CONTRACT NO. 1799

**SOLIDS THICKENING AND DEWATERING
IMPROVEMENTS**

ADDENDUM NO. 3

- 3.13 On Sheet 400-H-100, **ADD** the following sentence to the end of Key Note 91:
- “8” FOUL AIR DUCTWORK TO BE CPVC AND HAVE THE SAME SCHEDULE

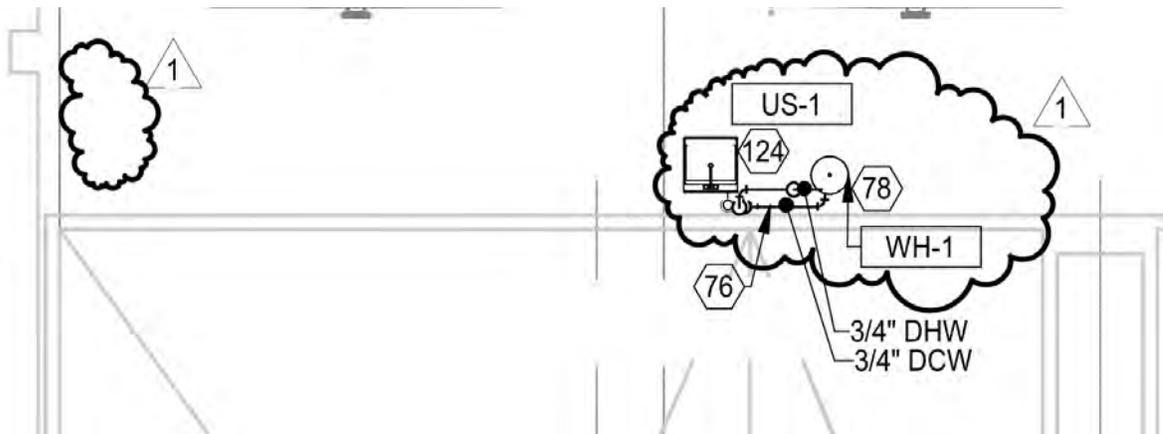
AS THE EXISTING DUCTWORK BEING CONNECTED TO.”

THICKENING FEED TANK MIXER ROOM - LOWER LEVEL PLAN
SCALE: 1/4" = 1'-0"

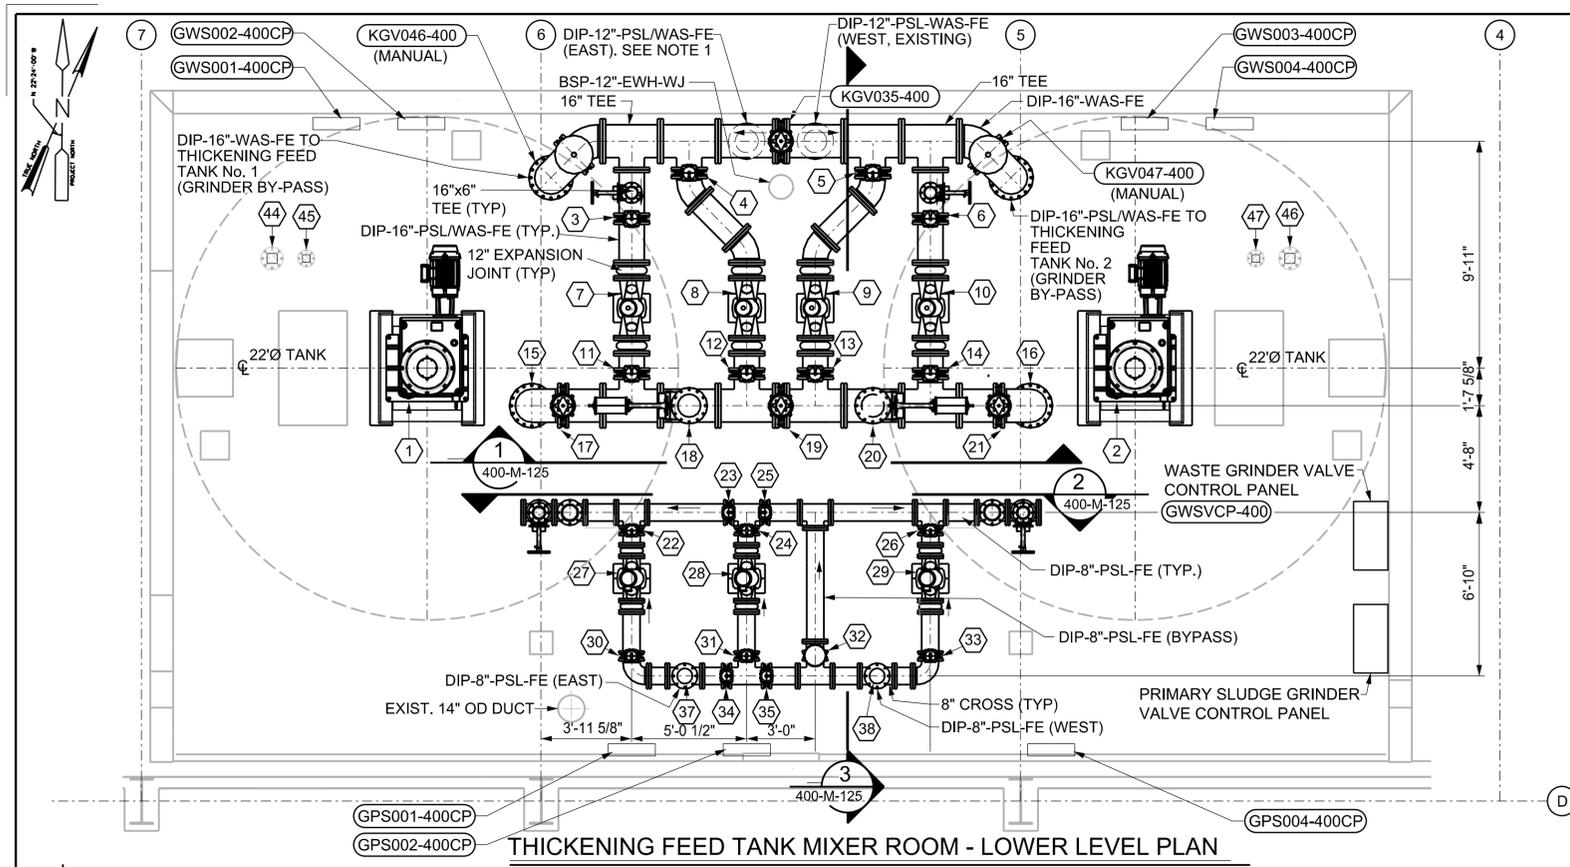
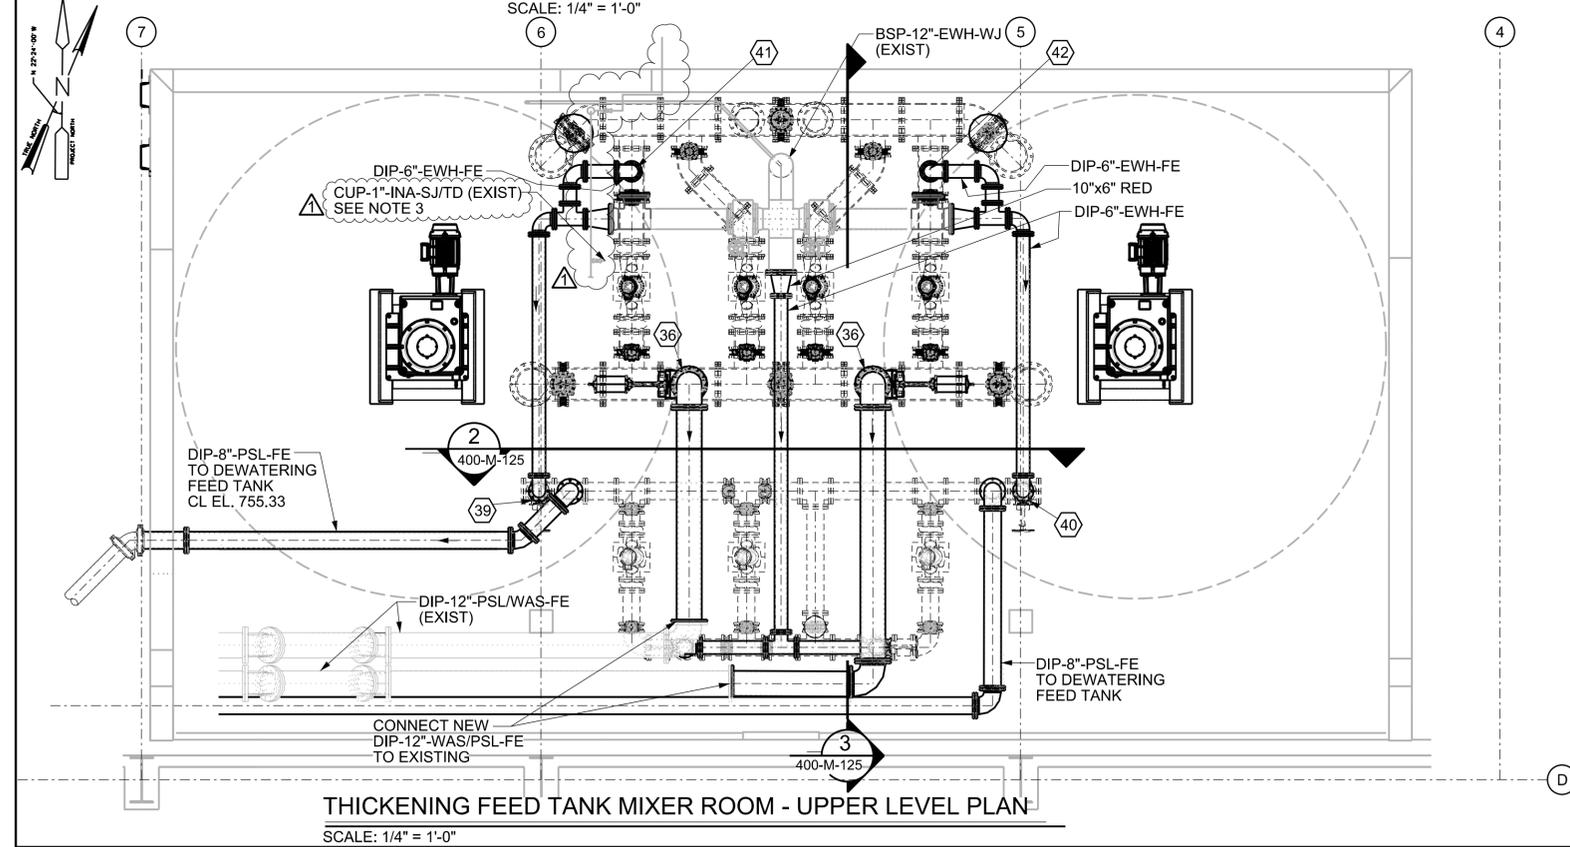
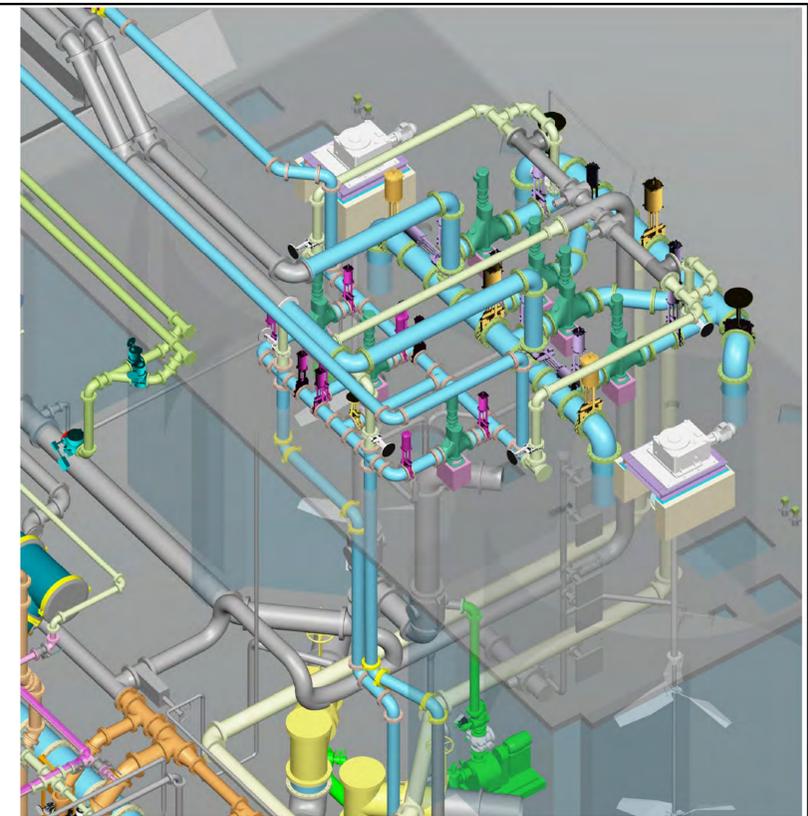
3.10 On Sheet 400-MDM-122, **DELETE** the callout “PNEUMATICALLY OPERATED KGV (TYP)” and **REPLACE** with “REMOVE PNEUMATICALLY OPERATED KGV AND ASSOCIATED AIR PIPING (TYP).”

Contract: 1799
CAD File Name: 701-ET-001.DWG
Date: 07 / 11 / 2024
Sheet: 271 of 440

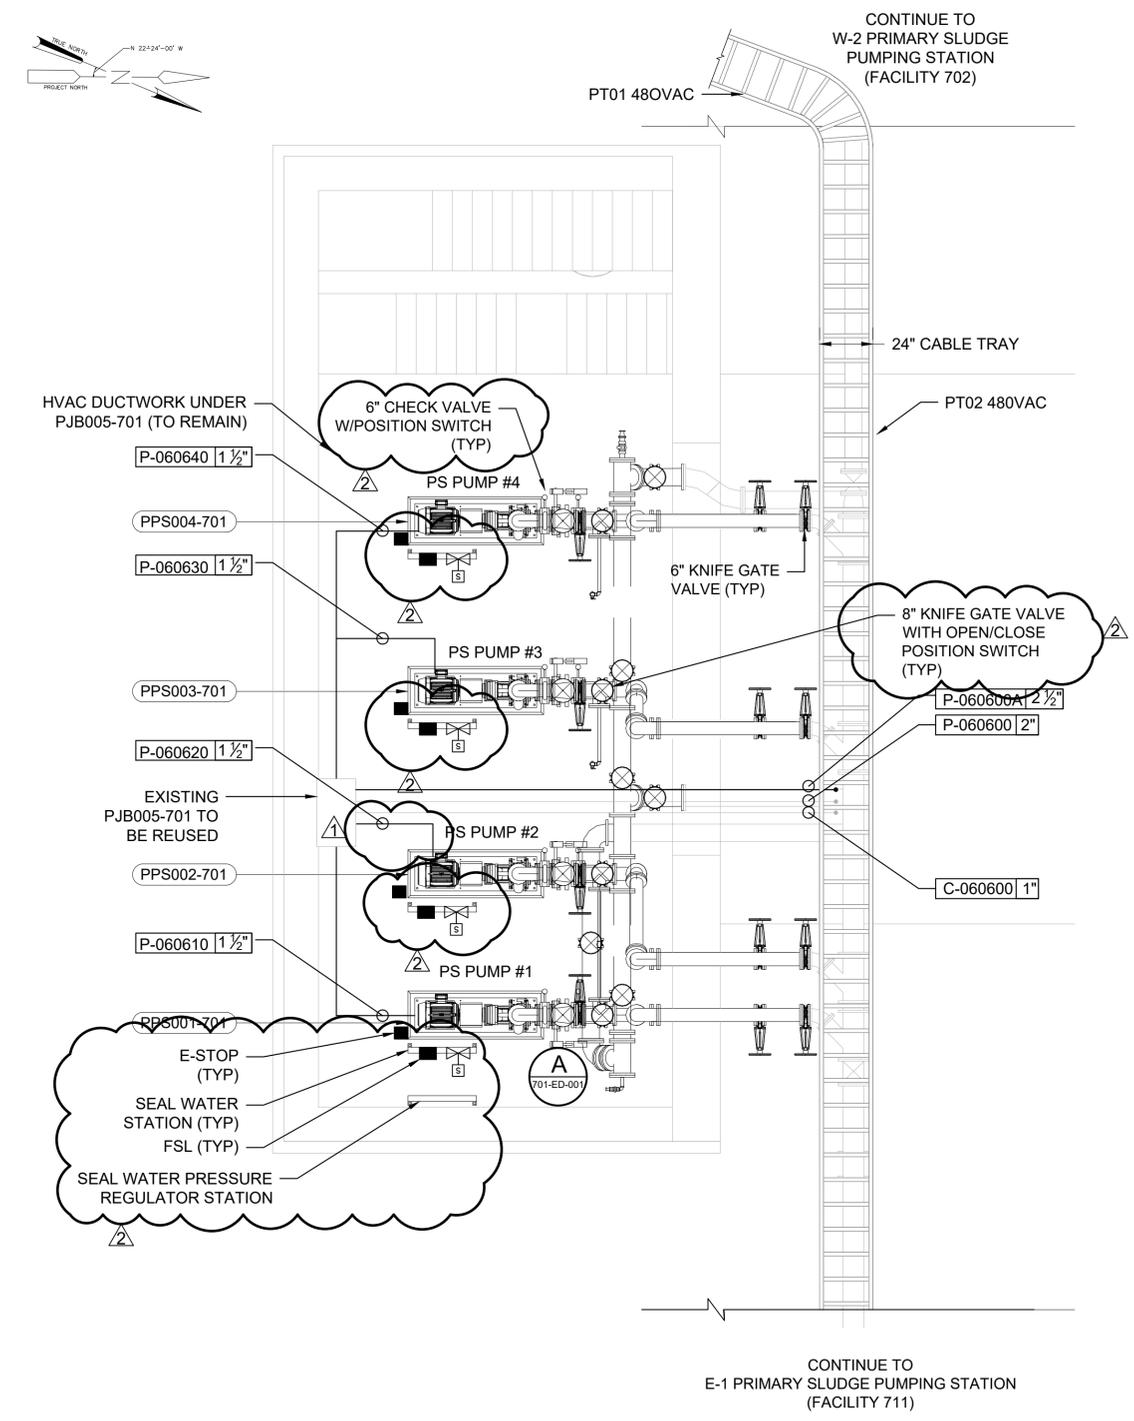
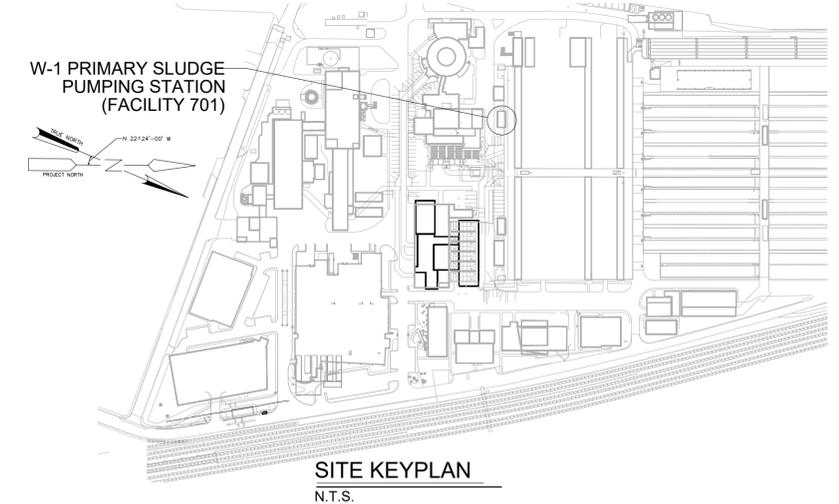
- Q39:** Drawing 701-ET-001 – Electrical Power Plan – Conduit and Cable ID No. P-060610, P-060620, P-060630 and P-060640 are all scheduled to be 1-1/2” Conduit from the PS Pump to the Existing PJB004-701 Junction Box. Addendum No. 1 - Drawing 701-ED-001 – Electrical Riser Diagram – Detail A Conduit and Cable ID No. P-060610 these same conduits are scheduled to be 1” Conduit. This detail is typical for (4) Pumps. Confirm which is correct.

- A39:** See Changes to the Drawings in this Addendum No. 3.
- Q40:** Addendum No. 1 – Drawing 701-ED-001 – Electrical Riser Diagram – Detail A – We have the following issues:
P-060612 – this does not show on the cable schedule
P-060612 –
Detail A shows a 3/4” Conduit while there is a 2 in the remarks for the cable schedule. We assume the remarks indicate the conduit sizes.
Detail A shows this conduit going from PJB001-700 to FSL then P-060614 to the Solenoid while the cable schedule shows this conduit going to PT04-480VAC. (Note P-060614 does not show on the cable schedule).
